DEPARTMENTS OF THE ARMY AND THE AIR FORCE
TECHNICAL BULLETIN

AVIATION GROUND POWER UNIT
(FUEL FILTER/SEPARATOR REPLACEMENT)

NSN 1730-01-144-1897

30 January 1998

Figure 1. Fuel Pump and Filter Installation

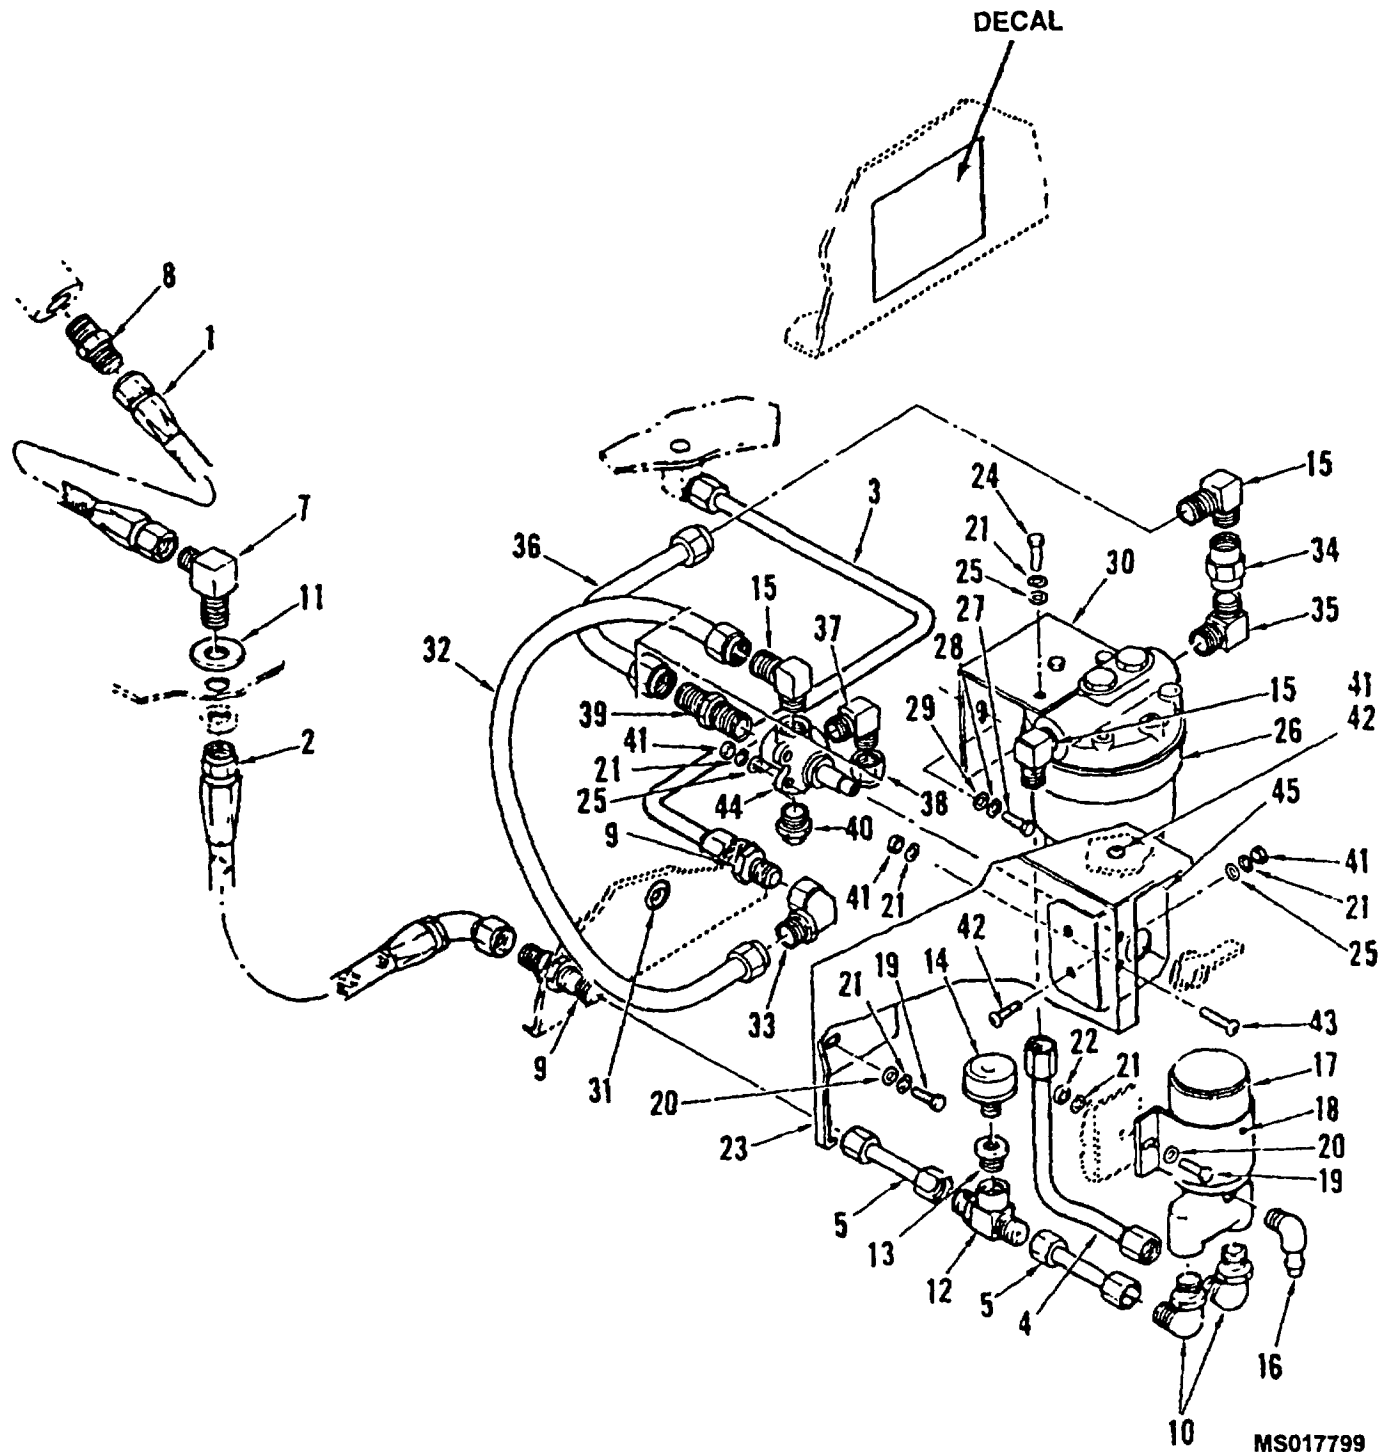
4. Removal of Kaydon Filter. Refer to Figure 1.

- a. Turn the AGPU OFF.
- b. Turn the fuel valve OFF.
- c. Position the drain pan under the AGPU fuel pump. Drain the fuel.
- d. Remove fuel tube, item 4 at only the fuel pump elbow, item 10.
- e. Remove fuel hose, item 36 at only the filter separator connection at item 15. Use two wrenches to stabilize the hose and loosen the fitting.
- f. Remove fasteners items 27, 28, 29 holding the fuel support bracket to the AGPU frame. The easiest method to loosen the screws is to reach around the air cleaner box just to the right of the filter separator. There are weldnuts secured to the inside of the AGPU frame that are not to be removed. The removed fasteners will be used to attach the new filter support bracket.
- g. Disconnect the battery cable from the battery.

- h. Remove the filter separator from the AGPU.
- i. Remove the 90 degree fuel tube item 4 from the filter separator and item 15 that was connected to item 4. The fuel tube item 4 will be reused for the new filter/separator.
- j. Remove items 15, 34, and 35 from the filter separator.
- k. Clean items 15, 34, and 35 and inspect threads for damage. If acceptable, these items will be reused for the new filter separator. Replace damaged or corroded items. Replace items that could possibly leak.
- l. Clean the area of the AGPU frame in the location of the Kaydon filter separator.

Figure 2. Racor Filter/ Separator Installation
(TOP VIEW)

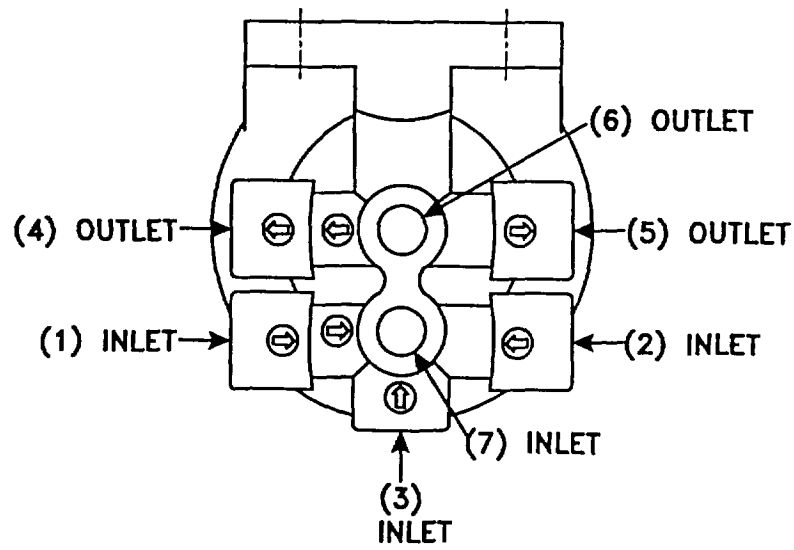
5. Installation of Racor Filter /Separator. Refer to figure 2.

c. Using a 5/16 allen wrench install the five plugs at the inlet and outlet ports as shown in figure 2 at locations 1, 3, 5, 6, 7. The plugs are located in a plastic bag that is supplied with the Racor filter separator. Use pipe dope and install them per para a. above.

d. Installation of the inlet fittings Refer to figure 1 and figure 2. Install 90 degree elbow (item 35, figure 1), and adapter tube (item 15, figure 2). Orient the plumbing assembly at 50 degree as shown in figure 3. Use pipe dope and install per para a, above.

Figure 3. Racor Filter/ Separator Installation
(RIGHT SIDE VIEW)

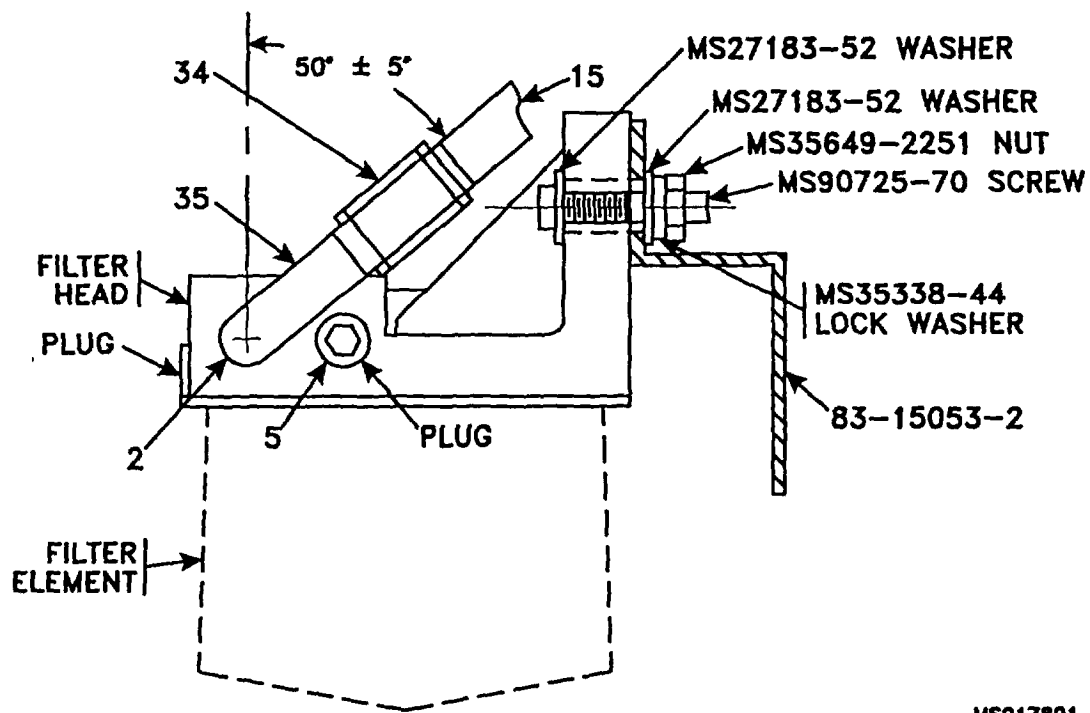
f. Attachment of fuel filter support (P/N 83-15053-2) to filter head Position the support as shown in figure 3 with the leg with the smaller holes (.25 in. dia) adjacent to the filter head. The two slots should be below the filter head and will attach to the AGPU frame. Hardware supplied to attach the support is four MS27183-52 washers, two MS90725-10 1/4x20 UNC x 1.25 screws, two MS35338-44 lockwashers, two MS51967-2 nuts, 1/4-20 UNC-2B. Do not tighten the nuts until after the final installation on the AGPU.

h. Attach the fuel hose (item 36, figure 1) to (item 15, figure 3). Do not tighten the fitting.

Figure 4. Illustrated Parts Breakdown

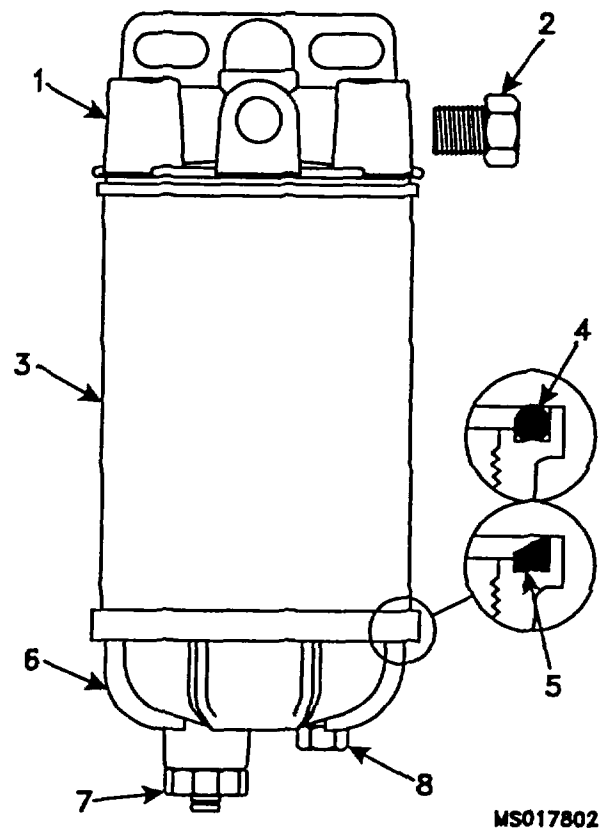
6. Illustrated Parts Breakdown for the Racor filter is shown in figure 4.
